SUBJECT: Transmittal of Revised Responses to AP1000 DSER Open Items

**AP1000 Design Certification Review
Draft Safety Evaluation Report Open Item Non-Proprietary Responses**

DSER Open Item Number: Reactor Systems Audit – Action Item 5

DSER Open Item Number: 15.2.7-1 Item 7 Revision 2

Figure 1: Cold Water Droplet Size Sensitivity

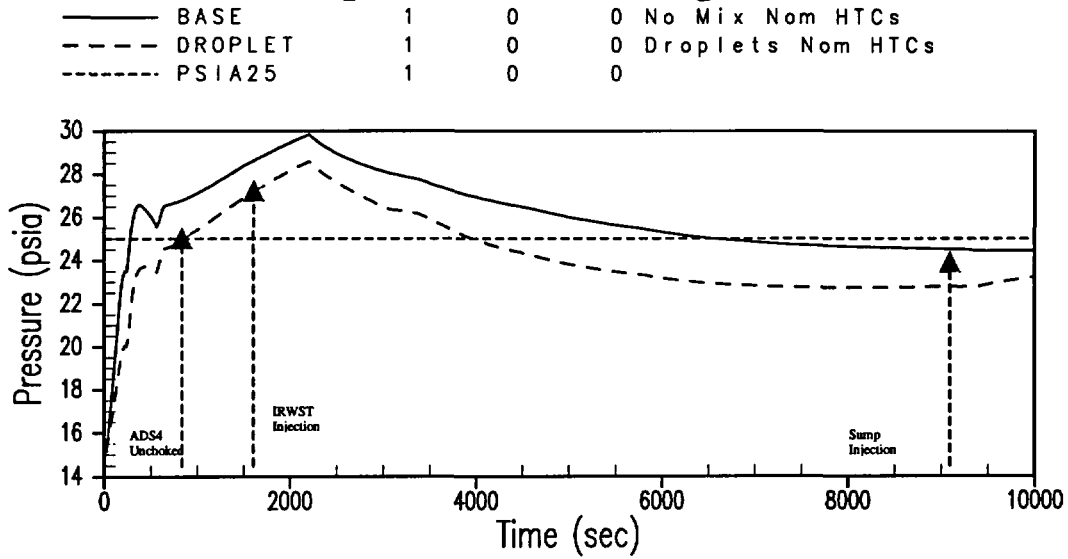
The DEDVI break consists of two break flow paths; one from the vessel side, and one from the loop side. The vessel side break is a typical high-temperature, high-pressure two-phase blowdown. This two-phase flow is assumed to form droplets that are dispersed into the atmosphere of the break compartment. The recommended drop size is 100 microns. The loop side break flow consists of low-temperature (~80F), high-pressure single phase water. Normally, this water is spilled to the floor of the compartment and is not assumed to interact with the vapor-space region of the compartment. For this sensitivity study, the loop side break flow is assumed to be dispersed into the atmosphere of the break compartment.

Figure 1 shows the containment pressure response for the two cases. By allowing the cold water to interact with the steam and two-phase mixture in the compartment vapor space, the overall pressure is reduced by approximately 2 psi. The pressure remains above 25 psia between the time that the ADS4 flow becomes non-critical and the time of IRWST injection. The interaction between the steam and the water droplets in the compartment causes steam to condense resulting in less steam to pressurize the containment. In addition, the water droplets are heated so that the water accumulating on the compartment floor is saturated.

Figure 2: Heat Transfer Multiplier Sensitivity

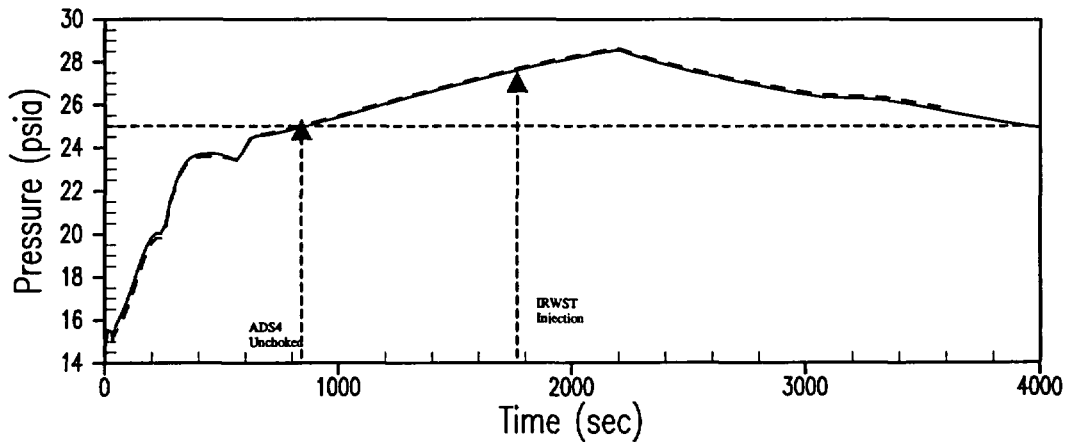
The Tagami correlation is not considered appropriate for use in small break LOCA analysis. This correlation was developed to account for significant forced convection heat transfer that takes place during the blowdown period of a large break LOCA. This time period is about 30 seconds. For the DEDVI, the "blowdown" period extends to about 500 seconds during which an equivalent amount of energy is released from the RCS to the containment atmosphere as occurs for the large break LOCA. Since the forced convection in containment depends on a characteristic velocity, the velocities inside containment during the blowdown period can be compared for the two events by comparing the blowdown time. Thus, it is likely that the velocities would be at least a factor of ten lower for the DEDVI than for the DECL during the blowdown, and since the forced convection heat transfer coefficient is roughly proportional to the velocity, use of Tagami during a small break LOCA blowdown would significantly overpredict the forced convection heat transfer. The Uchida correlation is recommended for these analyses.

As a sensitivity, the multiplier on the Uchida correlation was increased to 4.0 during the blowdown period (<500 seconds). Figure 2 shows the containment pressure response with and without this multiplier assuming mixing of the cold water spill as described above. These results show little sensitivity to the increased heat transfer coefficient.

The results of these sensitivity studies show that the containment backpressure boundary condition of 25 psia is valid for use in the DEDVI small break LOCA analysis.

Figure A-1: AP1000 Containment Backpressure Sensitivity

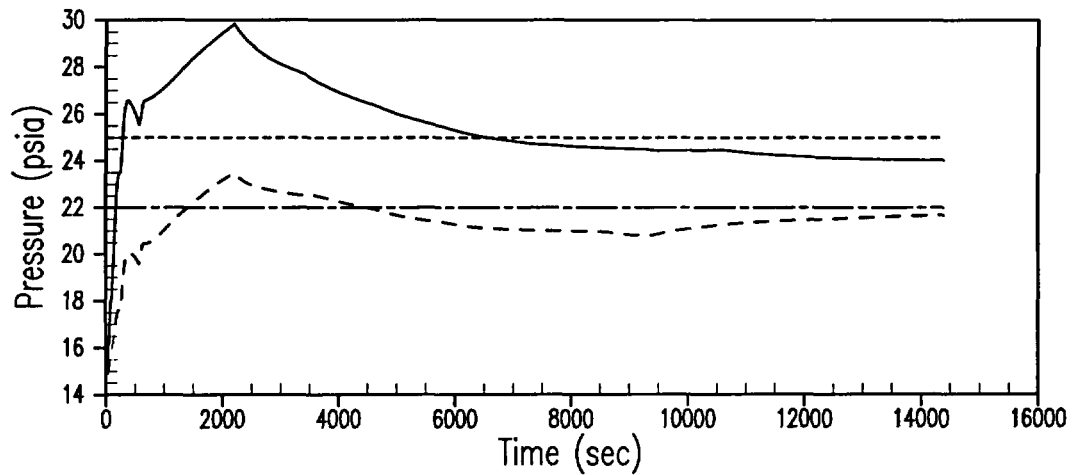
4. It is the staff's recommendation that the WGOthic small-break LOCA and long-term cooling model be modified to include the most conservative assumptions from the WGOthic minimum pressure for large-break LOCA model. Specifically,

- a. The containment net volume should be increased by a factor of 1.1
 - b. The containment shell and PCS heat structure area should be increased by a factor of 1.1

- c. The remaining head structure areas should be increased by a factor of 2.1 or a lower value if justified based on an accounting of expected structures in the final as-build plant.

- d. The Uchida correlation with a multiplier of 1.2 should be used for passive heat structures (non PCS structures throughout the accident.
 - e. The PCS heat and mass transfer correlation multipliers should be appropriately biased to account for the uncertainty in the experimental data base, and forced convection should be included on the PCS inner surface

- f. Head transfer in dead-ended compartments below the operating deck should not be turned off at the end of blowdown.

- g. The air-gap between the steel and the concrete should be reduced from the 20-mill thickness used in the maximum pressure calculation. A zero thickness air-gap would be conservative.
- h. The material properties should be biased high for conservatism.
- i. Heat transfer credit for the PCS should start earlier than is currently assumed for the maximum pressure calculation.
- j. Westinghouse should maintain its treatment of ECCS spillage as implemented in 1979.
- k. The containment purge system should be assumed to be operating and isolate on high pressure signal
- l. The initial and boundary conditions for the PCS water and environment should be provided with their justification for staff review.

The NRC recommendations listed above were incorporated into the WGOOTHIC small-break LOCA and long-term cooling model, and the pressure response to a double-ended DVI break LOCA is shown in Figure A-1 as the NRC case. Also shown as the base case is the pressure using the assumptions from the approved methodology in Reference 2.

The following are Westinghouse comments regarding the recommendations of the staff assessment and discussion of the parameters used in the WGOOTHIC analyses for Figure A-1:

- a. The main parameters of the volume enclosed by the containment shell are established by an ITAAC that requires the dimension of the shell inside diameter and height above the operating deck. Major structures and components inside containment are also identified in ITAAC. Uncertainties associated with the volume of the structures and equipment inside containment will result in a small uncertainty in the net free volume. The base case uses a multiplier of 1.05 to conservatively account for this uncertainty. The NRC case uses a multiplier of 1.1.

- b. The containment shell dimensions (shell inside diameter and height above the operating deck) are established by ITAAC. Also the water film on the external surface of the containment shell is assumed to distribute evenly around the entire circumference of the containment shell to maximize the effectiveness of the PCS heat transfer area. The base case uses a factor of 1.05 on PCS heat transfer area to conservatively account for any residual uncertainty in PCS heat transfer area. The NRC case uses a factor of 1.1 for this uncertainty.

- c. The methodology for the WGOOTHIC small-break LOCA and long-term cooling containment backpressure was approved for AP600 in Reference 2. The WGOOTHIC model for minimum backpressure for large-break LOCA was completed before the passive heat sink information was finalized. Consequently, the passive heat sink area multiplier in the approved methodology, 1.05, was

doubled to account for this uncertainty to 2.1. Since the results were within acceptable margins, there was no need to repeat the analysis as the design matured and the passive heat sinks were better defined. This large overconservatism was noted by the staff during review of AP600. The base case in Figure A-1 uses a 1.05 multiplier on heat sinks. The NRC case uses a 2.1 multiplier on heat sinks.

- d. As was noted in Reference 3, the use of the Tagami correlation is not appropriate for small-break LOCA. For the base case analysis the Uchida correlation is used with a 1.2 multiplier during blowdown and 1.0 multiplier after blowdown. For the NRC case the Uchida correlation is used with a 1.2 multiplier throughout the accident simulation.

- e. The base case uses multipliers of 1.0 on the PCS heat and mass transfer correlations. For the NRC case these multipliers were 1.19 and 1.37. Since WGOthic is being used in the lumped-parameter mode, the gas velocity is not known in the cells adjacent to the shell. Considering that velocities will be small for small-break LOCA events, forced convection is not modeled for either case.

- f. For both cases heat transfer in the dead-ended compartments was not turned off at the end of blowdown as recommended.
- g. The base case includes the air gap thickness. The air-gap thickness was eliminated for the NRC case.

- h. The material properties for steel, concrete and air were set to nominal values in the base case. For the NRC case, the properties were biased to maximize heat absorption.

- i. The PCS startup time was accounted for in the base case. The PCS was started at full flow at the start of the transient for the NRC case.
- j. The base case treats ECCS spillage as liquid flowing to the containment sump without interaction with containment atmosphere. Consistent with the Revision 1 of this Open Item response, for the NRC case the ECCS spillage is treated as a mist with a droplet size of 100 microns to maximize the heat transfer with the containment atmosphere.

- k. For both cases the containment purge system is assumed to open and isolates on a high containment pressure signal.
- l. For both cases the initial temperature (120F) and the initial humidity (100%) inside containment are biased high to minimize the amount of non-condensable gas at the start of the transient. For both cases the initial temperature and PCS temperature outside containment are biased low (40F) to maximize heat removal from the containment shell.

The NOTRUMP small-break LOCA response, and the WCOBRA/TRAC long term cooling response will be re-analyzed using the NRC case for the AP1000 DEDVI break. The results will be submitted in another revision to this response.
